Groundwater Application Review Summary Form

Application # G- 18795

GW Reviewer Ben Scandella, Justin Iverson Date Review Completed: 3/31/2020

PUBLIC INTEREST REVIEW FOR GROUNDWATER APPLICATIONS

Well Location Map

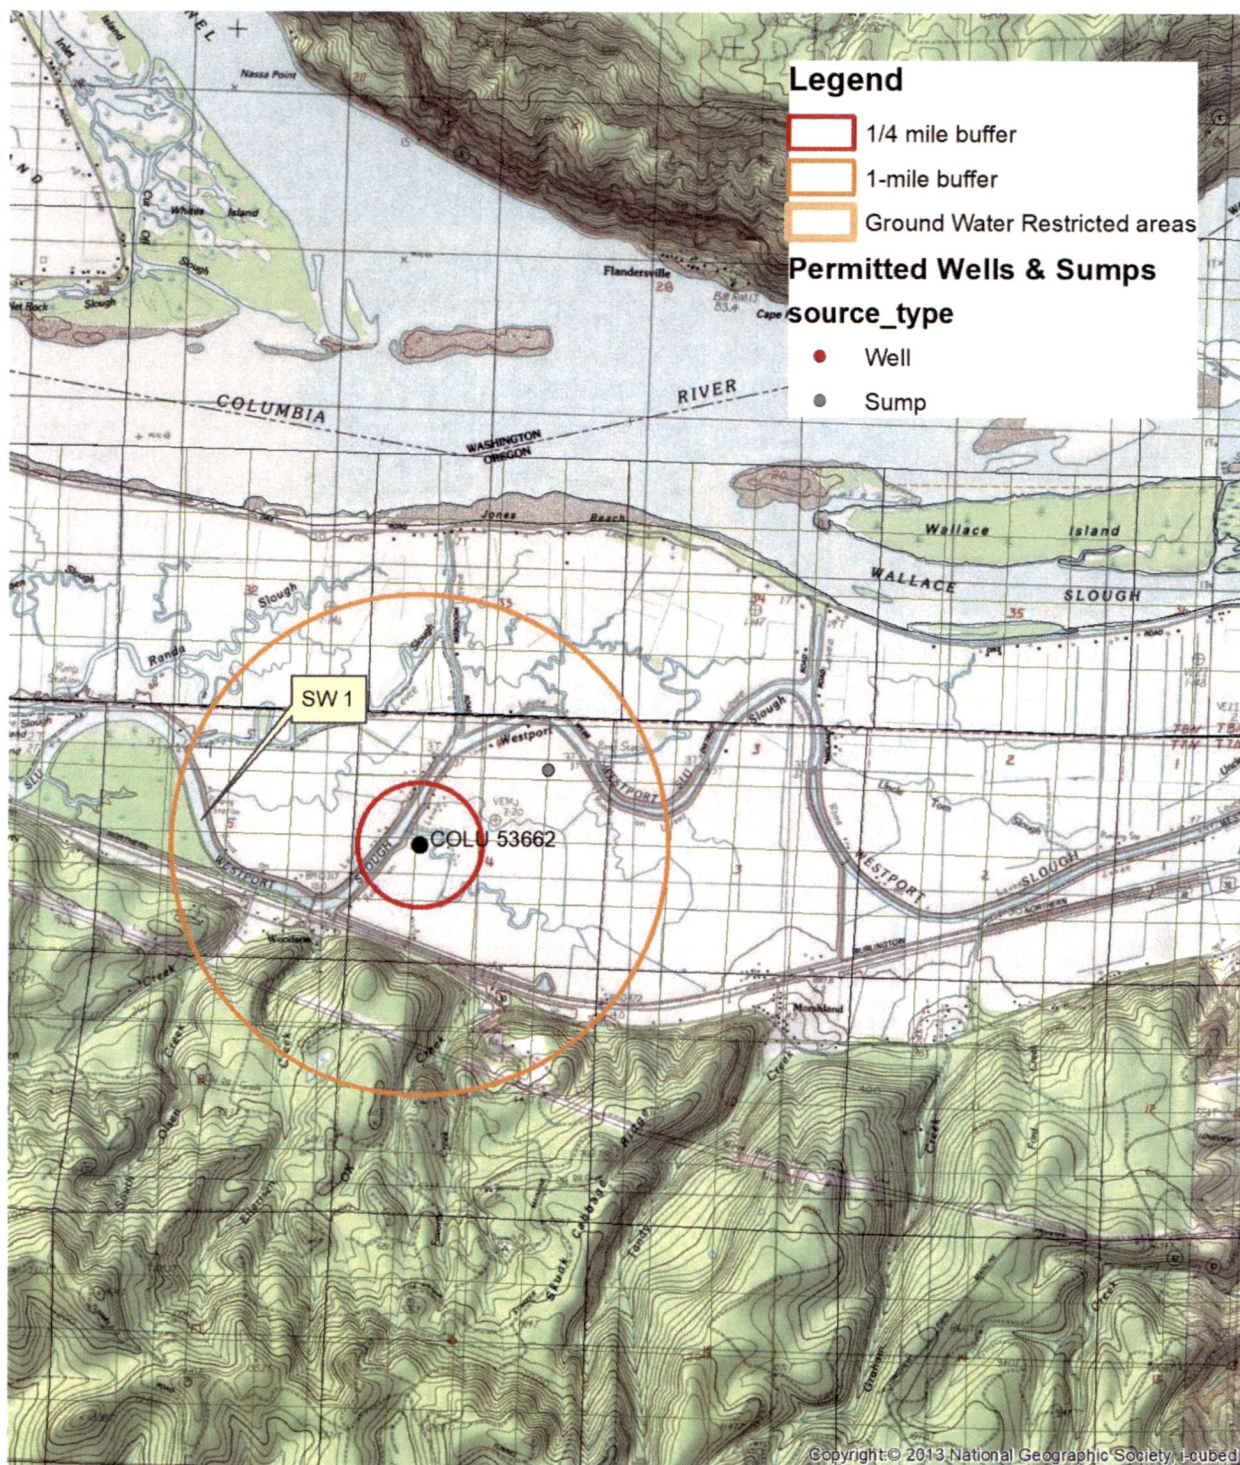
The proposed POA, COLU 53662, obtains groundwater from recent alluvium deposited by the Columbia River system. Water levels in many nearby well logs are reported to be within a few feet of ground surface, even during drier summer months, due to an extensive network of surface water features (canals and sloughs) located in this lowland area that are connected to the alluvial aquifer.

Furthermore, existing groundwater exploitation appears minimal in the area. The nearest groundwater right is Permit G-17247, for a shallow sump located about 3200 ft to the NE, and large tax lots suggest that neighboring domestic wells are also relatively distant. For this reason, there is minimal groundwater level data available; the next nearest well measurement in the OWRD database is from COLU 55222, about 6 miles to the east. The low allowed allocation, coupled with the surface- and groundwater rich environment and dearth of existing users, suggests that injury to any nearby users is highly unlikely.

Stream Depletion Modeling Results:

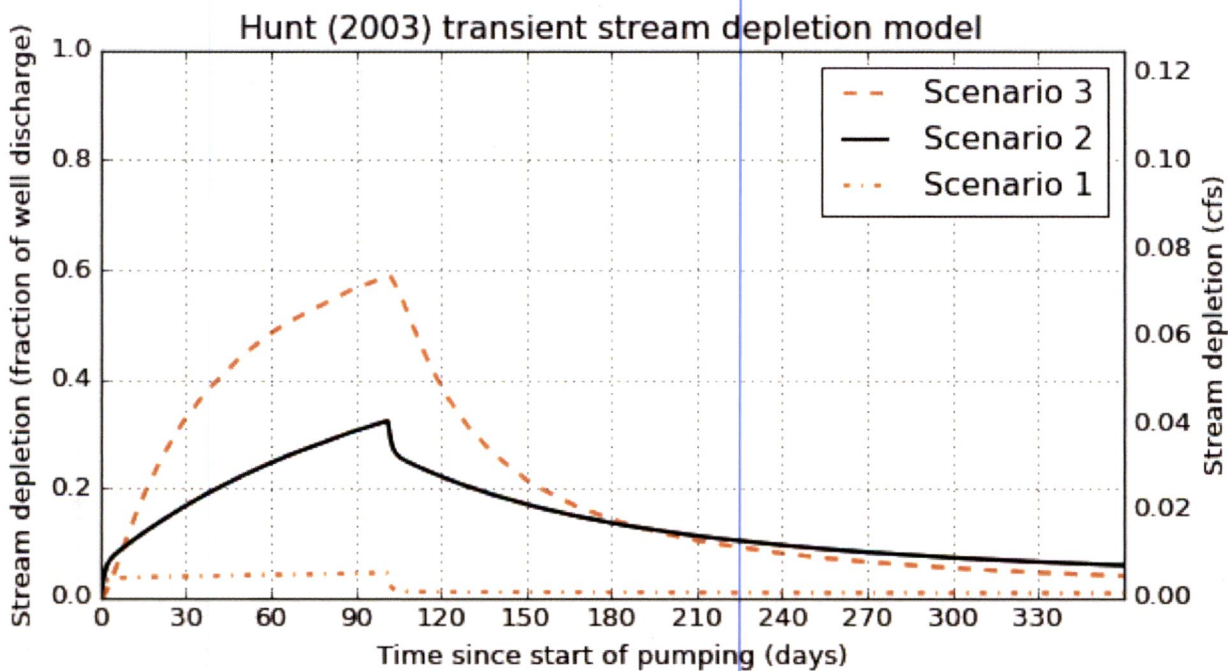
Comments: Using the Hunt, (2003) model and parameters appropriate for the hydrogeologic setting (Freeze and Cherry, 1979), streamflow depletion at 30 days is estimated to be likely less than 25% (see model parameters and results below).

Stream depletion for Scenario 2:
